## CONSUMER PRODUCT SAFETY COMMISSION

#### Safety Standard for Adult Portable Bed Rails

**ACTION:** Final rule.

Figure 2: Illustration from Figure 2 of ASTM F3186 – 17, Section 6.4

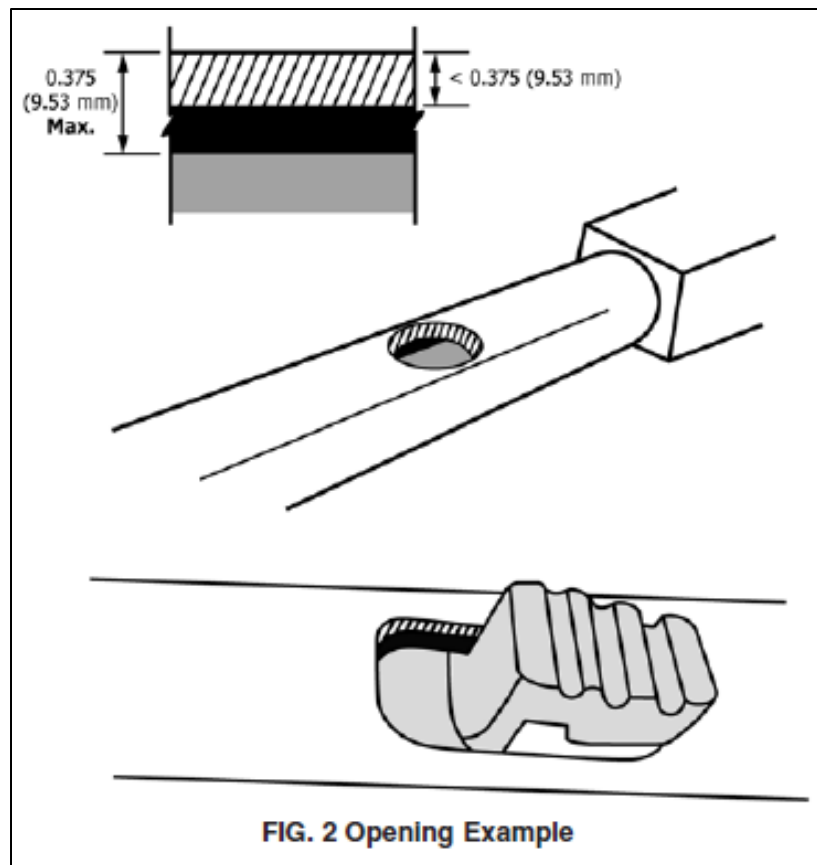
*Comment:* Louis A. Ferreira, of Stoel Rives, LLP, representing Stander, Inc. (Stander), a seller of APBRs, suggests that the NPR's proposal to regulate the sizes of holes or slots that extend entirely through a wall section on an APBR is not reasonably necessary to prevent or reduce an unreasonable risk of injury. Stander disagreed with the Commission's proposal to make the opening requirements consistent with standards for other products such as Children's Portable Bed Rails and instead suggests that the final rule should only correct consistency errors concerning dimensions in section 6.4 of the voluntary standard. Stander claimed that "the size of the holes do[es] not increase the risk of a fall or entrapment" and that "[t]here is not even

Section 6.4 of ASTM F3186-17 addresses the risk of finger entrapment and laceration in small holes or openings. Changes to this section are necessary to correct errors and inconsistent measurement references. Specifically, in stating the dimensions of the rods used to conduct testing, the standard inaccurately refers to 13 mm as the equivalent to 5/8 in. (whereas 5/8 in. is approximately 16 mm). Also, while the standard allows different dimensions for holes or slots that do not exceed 1/4 in. in depth, it refers to a drawing depicting a hole up to “.375 (9.53 mm) deep,” or 3/8 in., shown below in Figure 2.

Further, the proposed changes in the NPR are necessary to adequately address the risk of injury because the hole dimensions referenced by the commenter are not effective in protecting vulnerable adult populations. Vulnerable adults are often smaller and more frail than other populations of adults and are more likely to use APBR products. The proposed changes in the NPR align the rule with other established children’s product regulations that prevent hazards to a range of finger sizes that covers both children and adult users simultaneously.<sup>22</sup>

The Commission therefore concludes the language proposed in the NPR is necessary to address the range of foreseeable consumer exposures to potentially hazardous holes in APBRs. Therefore, no change will be made to the final rule based on this comment.

Figure 3: General example of areas subject to Zone 2 requirements.

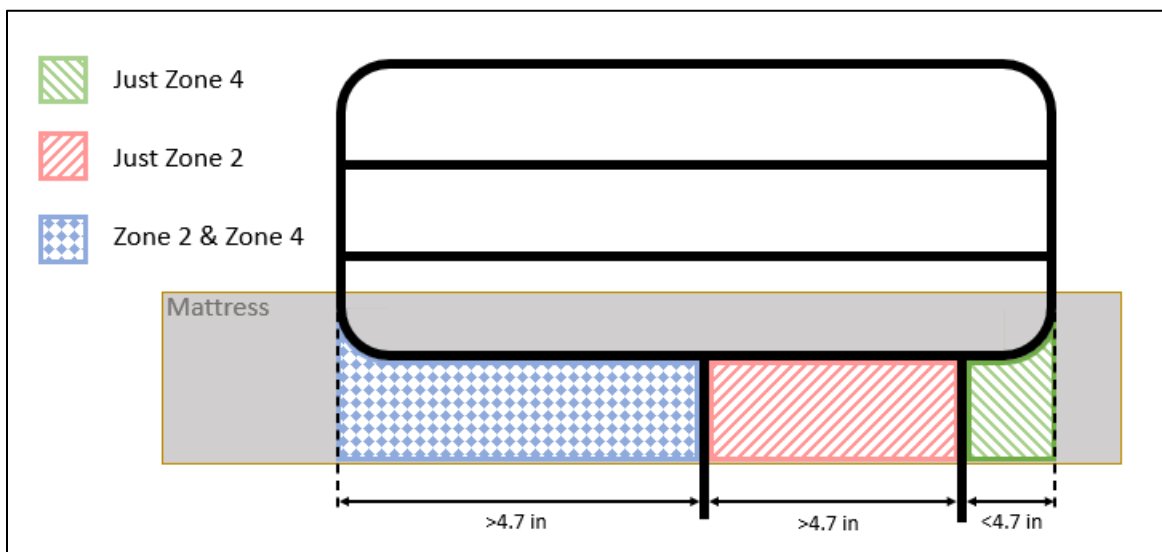
*Comment:* Luis A. Ferreira, representing Stander, suggested that staff's proposed entrapment test modifications are ambiguous and inadequate. Stander expresses concern "that the ASTM Standard with the proposed modifications could be misinterpreted, and a product fail the test, not because of any unreasonable risk posed by the bed rail, but simply because a mattress is selected for testing that is so soft that the probe can be pulled beneath the bottom rail of the APBR." Stander suggests making changes to the proposed entrapment test requirements of the NPR.

For example, per Zone 2, the known hazard is head-first entry under the rail in any section longer than the anthropometric head dimension of the entrapment test probe, which is 4.7 inches. Therefore, in Figure 3 below, both the left and right areas should meet Zone 2 requirements, in addition to the other applicable tests, to ensure the product adequately addresses the known hazard.

Safety testing should represent known hazard modes, including the displacement caused by consumers moving or pushing into the mattress or product, which may create an opening that was not previously visible. During entrapment zone testing, the positioning and application of the force via a force gauge must be realistic and representative of all reasonably foreseeable scenarios of consumer behavior. In many cases, applying the force to the probe by attaching a force gauge below the bottom of the rail is the most accurate representation of the worst case of this foreseeable hazard scenario. Additionally, in contrast to the current voluntary standard, entrapment hazards are not present only in the “largest opening” of a product. Entrapment hazards may exist in several areas depending on the product configuration and installation.

To ensure entrapment hazards are adequately addressed, products must be assessed in all areas that may constitute an entrapment zone. Therefore, in response to this comment, the Commission has revised the language in the final rule as follows:

Figure 1 to paragraph (b)(14)(i)—General Example of Areas Subject to Zone 2 Requirements

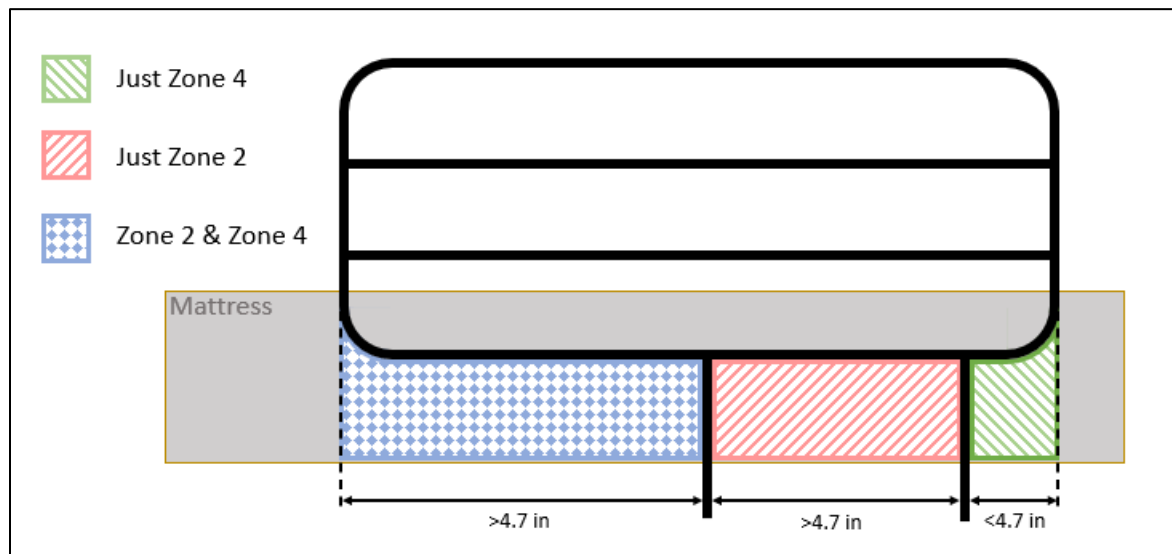
Additionally, § 1270.2(b)(14)(i) in the final rule has been revised from proposed § 1270.2(b)(13)(ii). Stander raised concerns about the location of Zone 2 on bed rails with multiple supports. Zone 2 testing is meant to address head-first entry under the rail into any opening between the mattress compressed by the weight of a consumer’s head and a section of the bedrail. Bed rails that have overhanging elements longer than 4.7 inches can allow the passage of the head in a manner consistent with identified Zone 2 entrapment hazards regardless of the number or location of vertical support rails. 4.7 inches is the diameter of the test probe and encompasses the 5th percentile female head breadth. Therefore, revised § 1270.2(b)(14)(i) clarifies which areas should be included in Zone 2 testing along with adding a new figure 1 illustration that visually depicts the clarifying language.

(i) If a horizontal section of the rail greater than 4.7 in exists along the bottom of the rail, that section must also meet the Zone 2 requirements regardless of the number or location of the supports. Repeat testing described in section 8.4.4.3 of ASTM F3186-17 (see paragraph (b)(12)(i) of this section) and section 8.4.4.4 of ASTM F3186-17 (see paragraph (b)(13)(i) of this section) for all applicable entrapment zones. Figure 1 to this paragraph (b)(14)(i) shows a general example of areas subject to Zone 2 requirements.
